MEMORANDUM

RE: OSDS Plan
3631 Paupers Folly Lane
Belvedere Estates, Lot 5

**PERMIT SITE PLAN
BELVEDERE ESTATES
LOT 5**

SEPTIC SYSTEM INSTALLATION SITE PLAN
BELVEDERE ESTATES
 LOT 5
 3631 PAUPERS FOLLY LANE
 ZONED: RC-DEO
 TAX MAP NO: 22 GRID NO: 8 PARCELS NO: 116 AND P.O. 7
 THIRD ELECTION DISTRICT HOWARD COUNTY, MARYLAND
 SCALE: AS SHOWN DATE: FEB. 13, 2020
 SHEET 1 OF 1

2-1 PARTIAL BUILDING SECTION
SCALE: 1/4" = 1'-0" (OPT. COVERED PORCH TYPE)

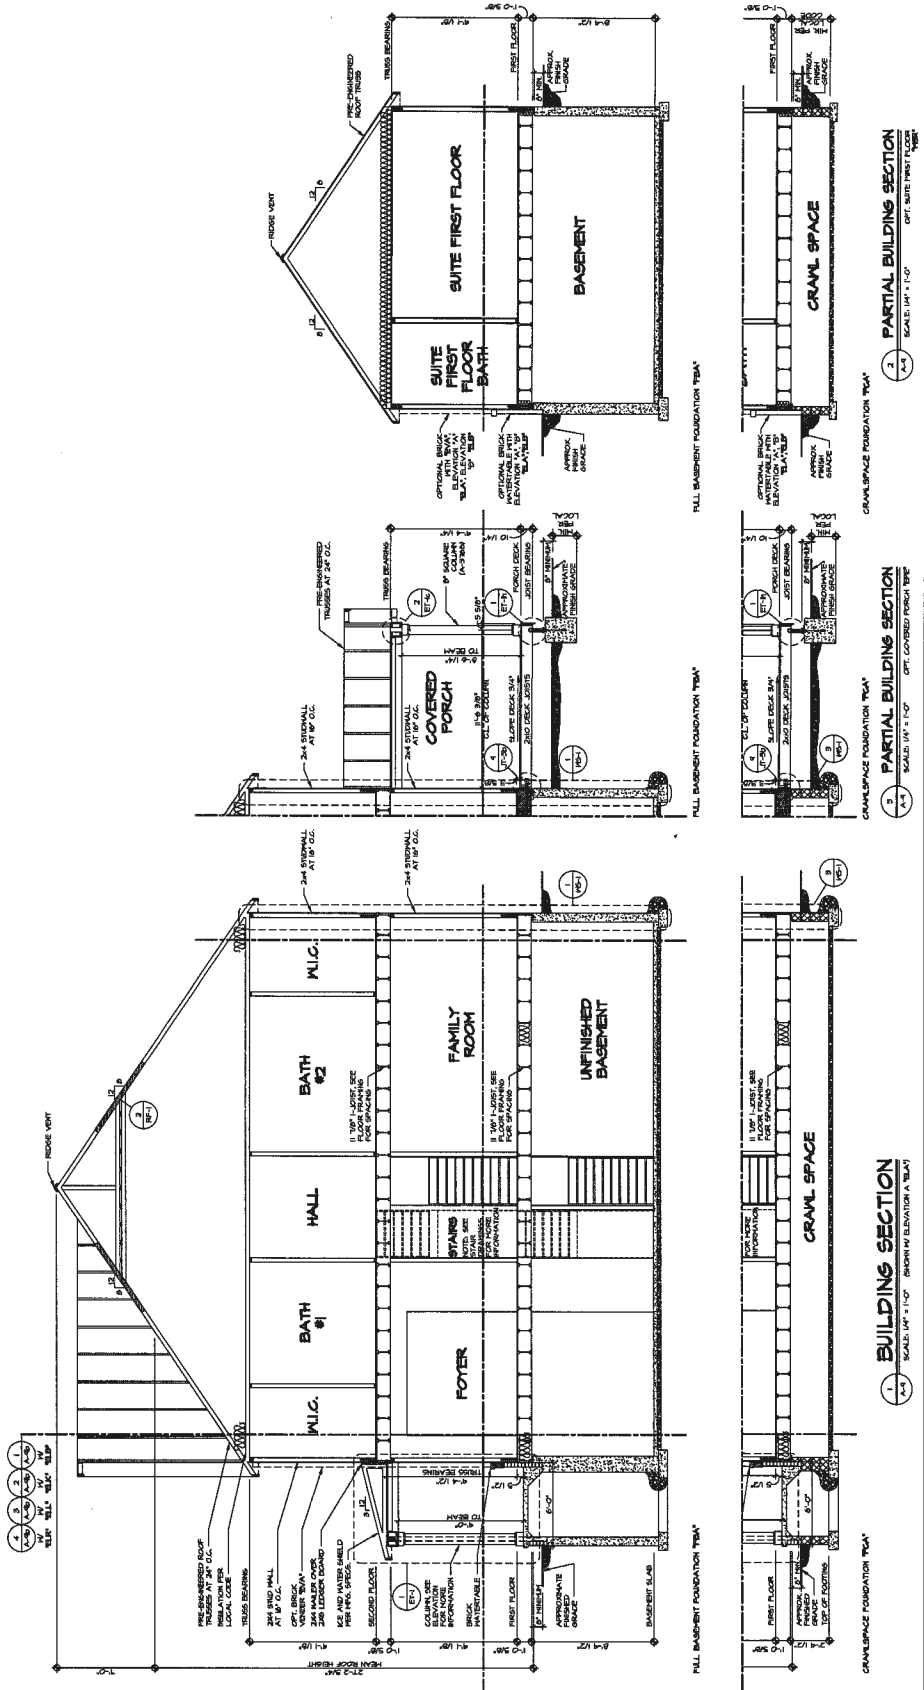
I noticed that some of the trench lengths in the 2nd replacement system is short of 58.59 feet. Also, the distance between the 1st and 2nd replacement trenches must be at least 8 feet given the side wall credit used in the 1st system. Additionally, per my first set of comments, the basement walkout is less than 20 feet from the SDA so this must be addressed. Lastly, details are still needed about the covered porch foundation.

Thanks for the email. I'll let Tony look into and resolve the trench layout issues. As for the walkout steps from the basement, I believe that's been allowed (it has been awhile since this has come up). It might be that a waiver letter was required. However, I am thinking that you now require that the homebuyer has to sign that waiver request letter? It used to be that we could simply request it on their behalf. Is that this case? The covered porch details are attached (posts on footers only).

Re: Belvedere Estates
Lot 5: 3631 Paupers Folly Lane
Waiver Request: Welled Exit

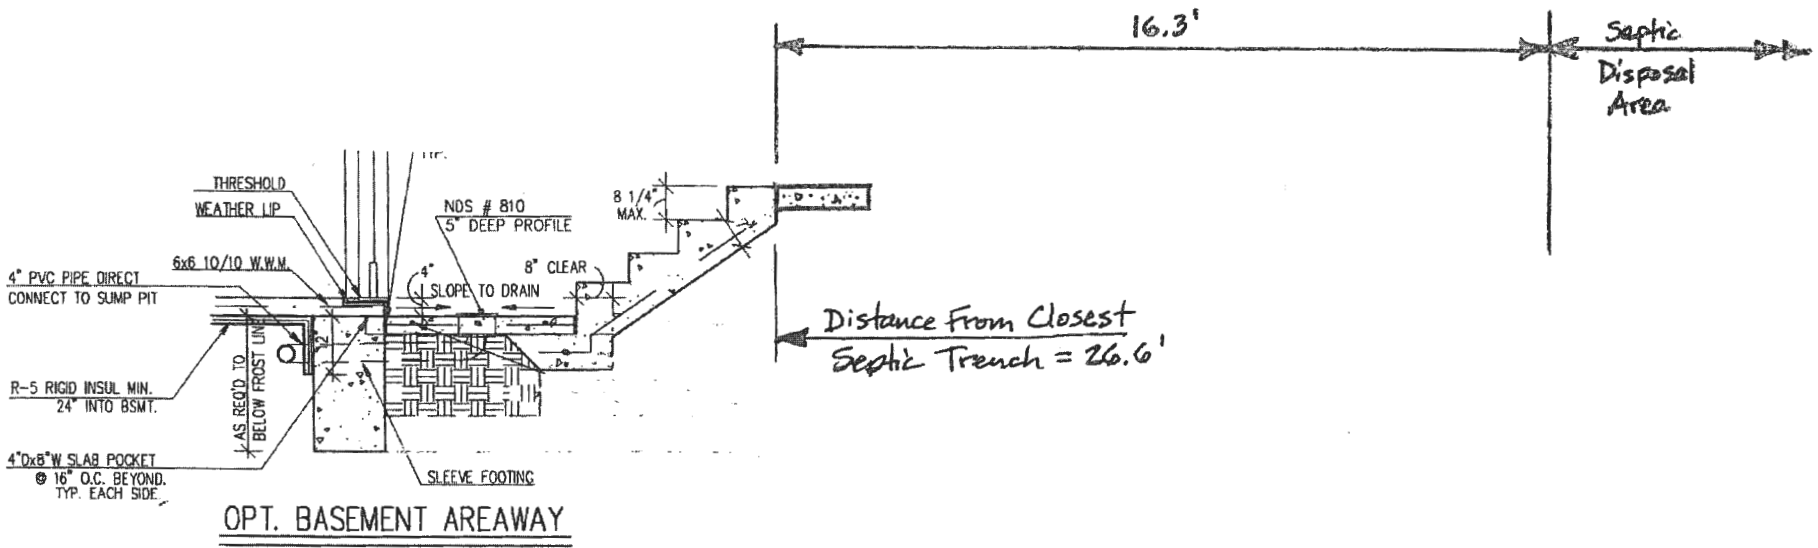
We are requesting a variance to allow the proposed welled exit (stairs exiting the basement door) to be constructed closer than 20 ft. to the approved sewage disposal area. From the outer edge of the last step to the sewage disposal area is approximately 16.3 ft. And the distance from the outer edge of the last step to the closest proposed septic trench is approximately 26.6 ft. (Fisher, Collins, & Carter, Inc. has provided a section/detail of this).

2/7/20
Approved
Joni J. Davis

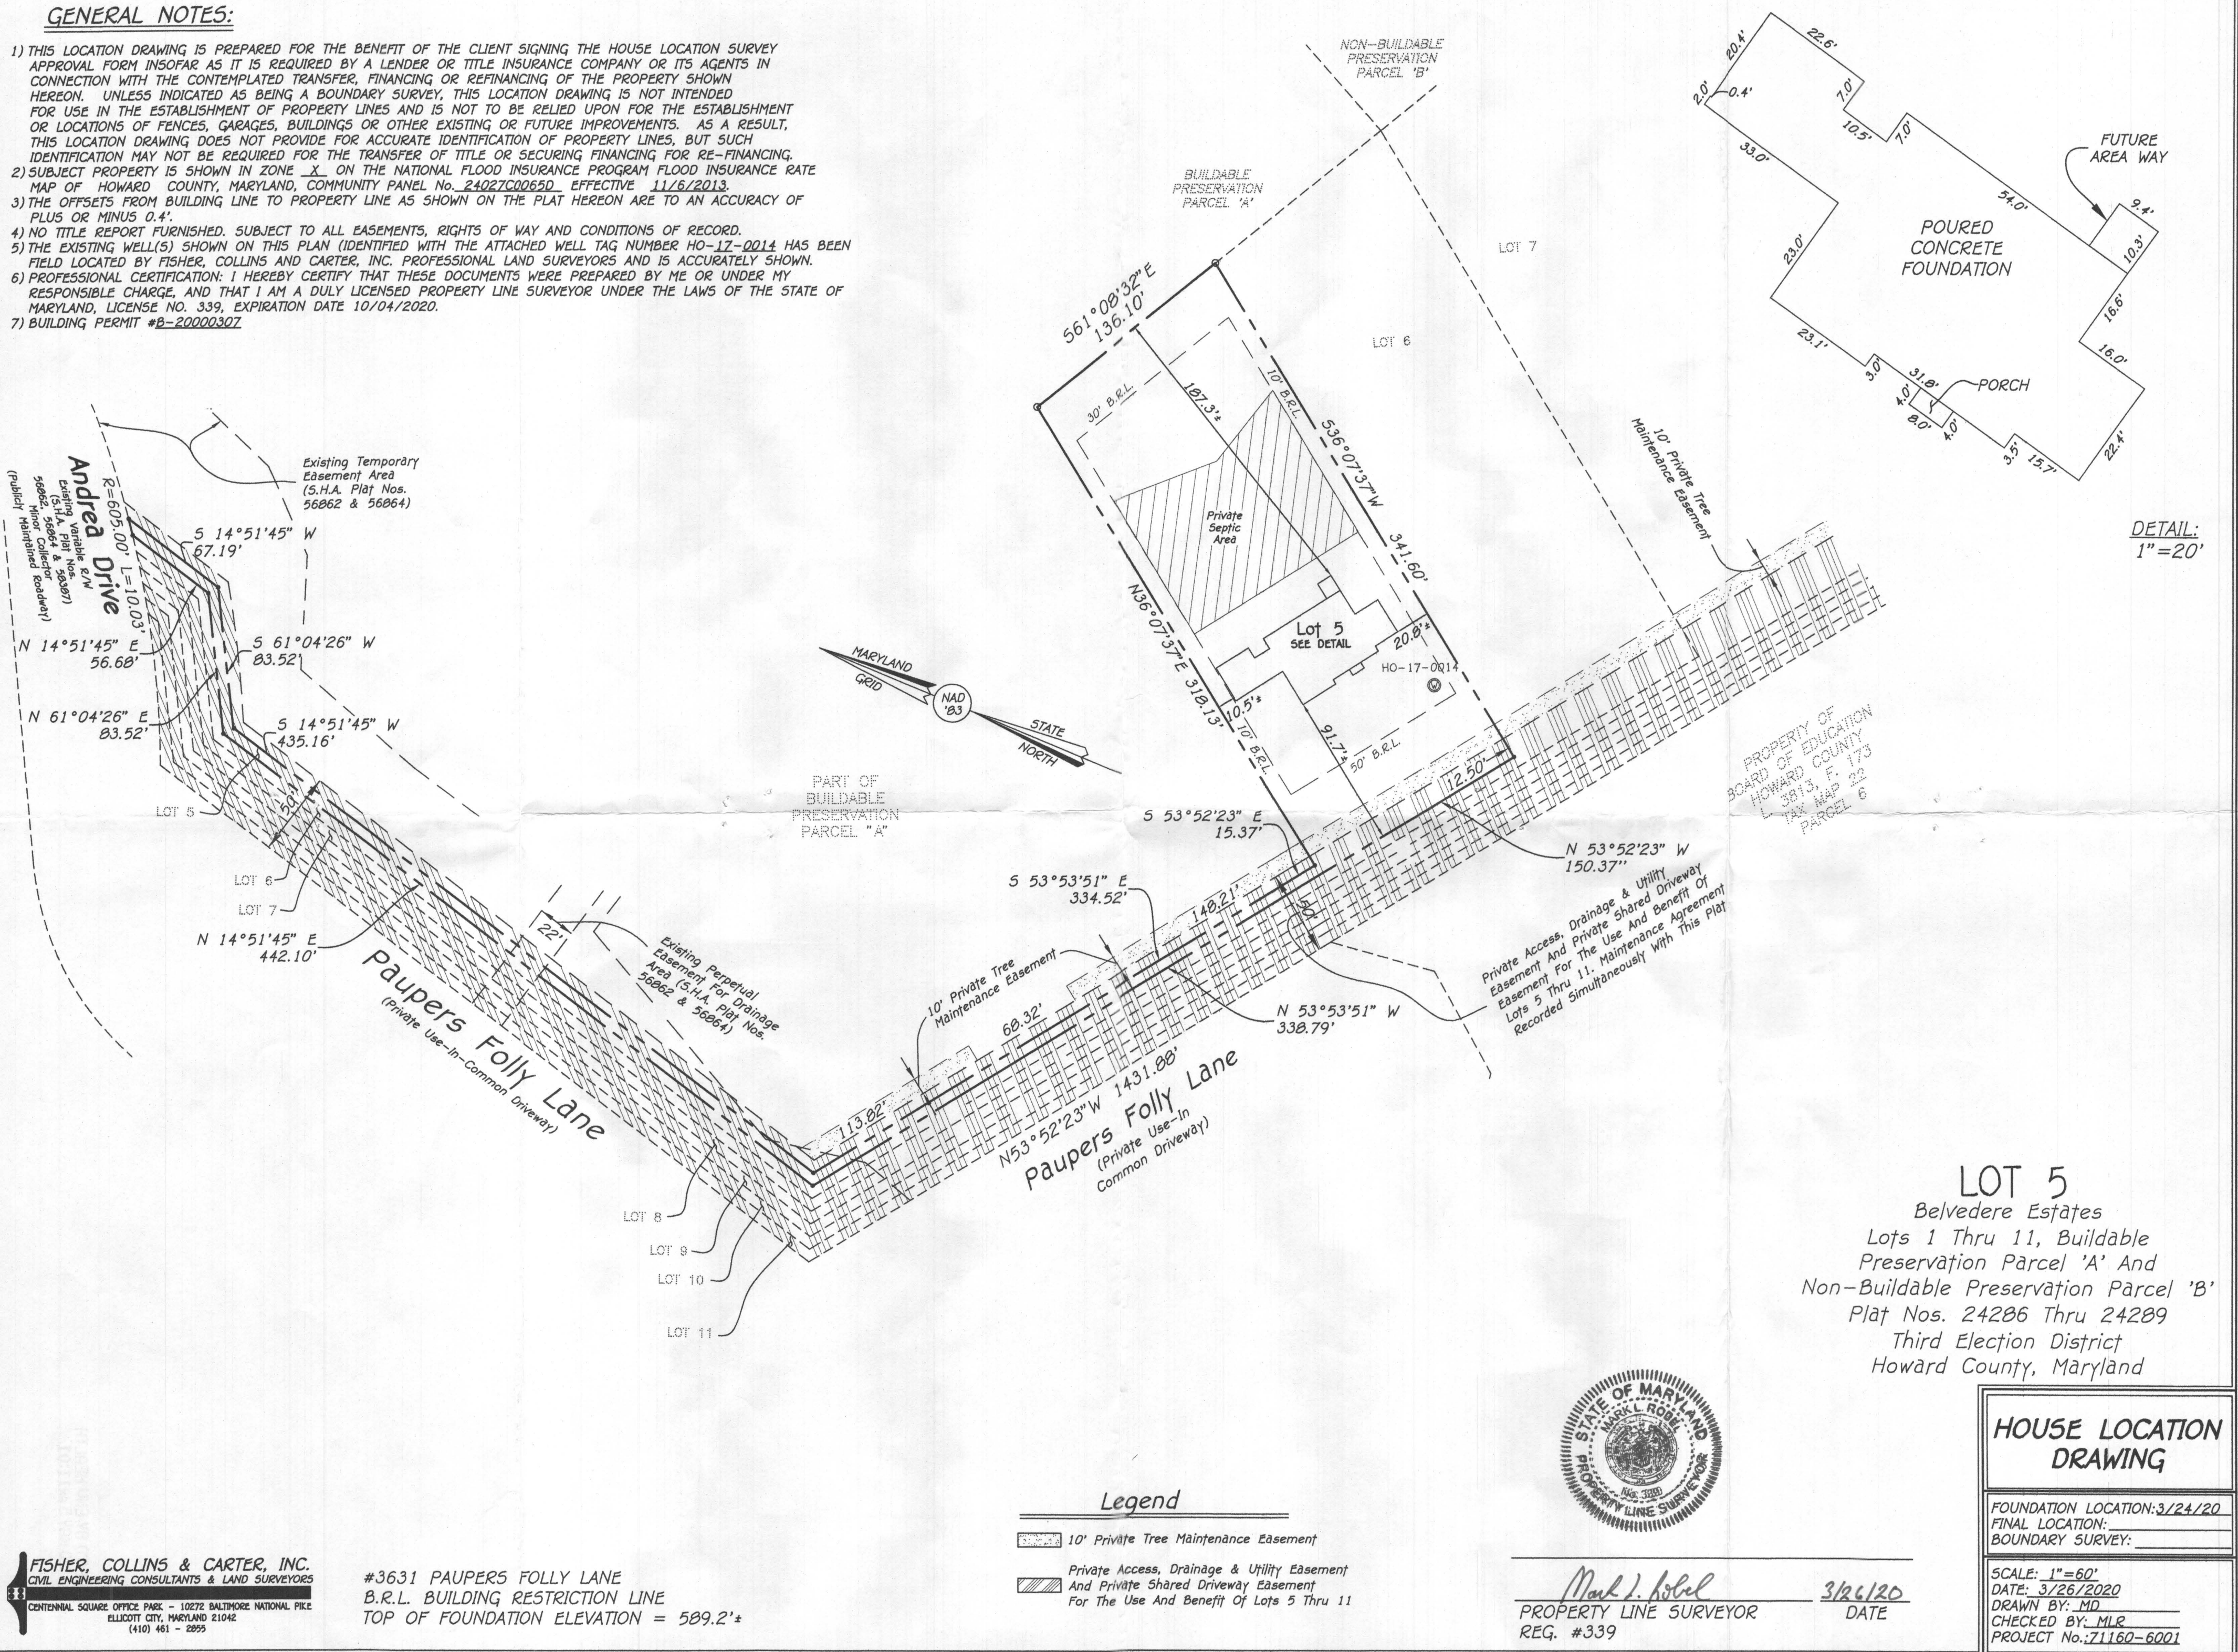
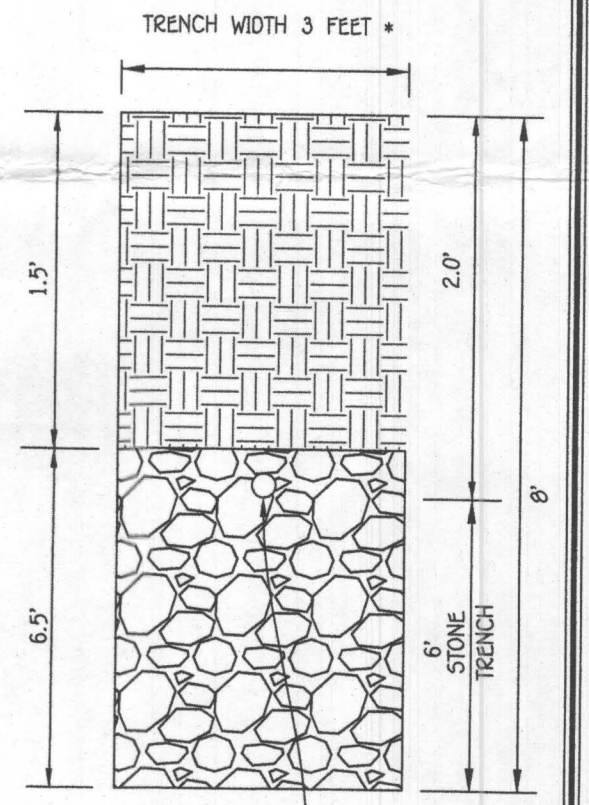
- 1.) Provide details about covered porch foundation (i.e. post footers etc.)
- 2.) Basement walk out is less than 20 feet to septic tank.
- 3.) Show perc test hole locations. See attached OSDS Plan requirements.
- 4.) Correct Initial trench detail.
- 5.) 2nd replacement system calculations are incorrect (effective area begins and ends at 6.5 feet). See attached septic spec worksheet.
- 6.) Note #4 - The well tag # is incorrect.

I noticed that some of the trench lengths in the 2nd replacement system is short of 58.59 feet. Also, the distance between the 1st and 2nd replacement trenches must be at least 8 feet given the side wall credit used in the 1st system. Additionally, per my first set of comments, the basement walkout is less than 20 feet from the SDA so this must be addressed. Lastly, details are still needed about the covered porch foundation.

The trench lengths in the calculations shown on the plan differ from your comment "I found that the required trench length was 52.08' (not 58.59)". Also, I noticed the 2nd replacement system calculation still shows a statement; *Effective sidewalk begins at 3 feet.*

In checking the comments compared to the OSDS plan, I found that the required trench length was 52.08' (not 58.59'). So I've labelled the trenches so it's more clear regarding which trenches are what. I've also adjusted the trenches somewhat to maintain 8 ft. of separation between the 1st and 2nd replacement trenches. So the two initial system trenches now have a circle around the number 1, and the 1st replacement trenches have a circle around the number 2. And the 2nd replacement system has a 3 with a circle around it. The other comments are resolved (waiver has been approved for welled exit) and the rear porch option shown to not be foundation, as the architectural plans I sent you show.

INITIAL SYSTEM ①
 SEWAGE DISPOSAL SYSTEM DATA, DESIGN FOR 5 BEDROOMS
 LOADING RATE = 5 BEDROOMS X 150 GPD/BEDROOM = 750 GPD
 APPLICATION RATE = 0.8
 EFFECTIVE SIDEWALL BEGINS AT 3 FEET
 TRENCH DEPTH = 8 FEET
 TRENCH WIDTH (W) = 3 FEET
 EFFECTIVE DEPTH (D) = 5 FEET
 SF OF DRAINFIELD = 750 GPD / 0.8 = 937.5 SF
 COEFFICIENT OF REDUCTION OF TRENCH LENGTH = (W+2)/(W+1+2D)=(3+2)/(3+1+(2x5))=0.357
 TRENCH LENGTH = 312.50 SF X 0.357 = 111.56 FEET
 (2 TRENCHES 55.78)
 TRENCH SPACING = 2D+W = (2x5) + 3 = 13' USE 13'

1ST REPLACEMENT SYSTEM ②
 SEWAGE DISPOSAL SYSTEM DATA, DESIGN FOR 5 BEDROOMS
 LOADING RATE = 5 BEDROOMS X 150 GPD/BEDROOM = 750 GPD
 APPLICATION RATE = 0.8
 EFFECTIVE SIDEWALL BEGINS AT 3 FEET
 TRENCH DEPTH = 8 FEET
 TRENCH WIDTH (W) = 3 FEET
 EFFECTIVE DEPTH (D) = 5 FEET
 SF OF DRAINFIELD = 750 GPD / 0.8 = 937.5 SF
 COEFFICIENT OF REDUCTION OF TRENCH LENGTH = (W+2)/(W+1+2D)=(3+2)/(3+1+(2x5))=0.357
 TRENCH LENGTH = 312.50 SF X 0.357 = 111.56 FEET
 (2 TRENCHES 55.78)
 TRENCH SPACING = 2D+W = (2x5) + 3 = 13' USE 13'

2ND REPLACEMENT SYSTEM ③
 SEWAGE DISPOSAL SYSTEM DATA, DESIGN FOR 5 BEDROOMS
 LOADING RATE = 5 BEDROOMS X 150 GPD/BEDROOM = 750 GPD
 APPLICATION RATE = 0.8
 EFFECTIVE SIDEWALL BEGINS AT 3 FEET
 TRENCH DEPTH = 6.5 FEET
 TRENCH WIDTH (W) = 2 FEET
 EFFECTIVE DEPTH (D) = 0 FEET
 SF OF DRAINFIELD = 750 GPD / 0.8 = 937.5 SF
 TRENCH LENGTH = 468.75 FEET
 (9 TRENCHES 52.08)
 TRENCH SPACING = 6'
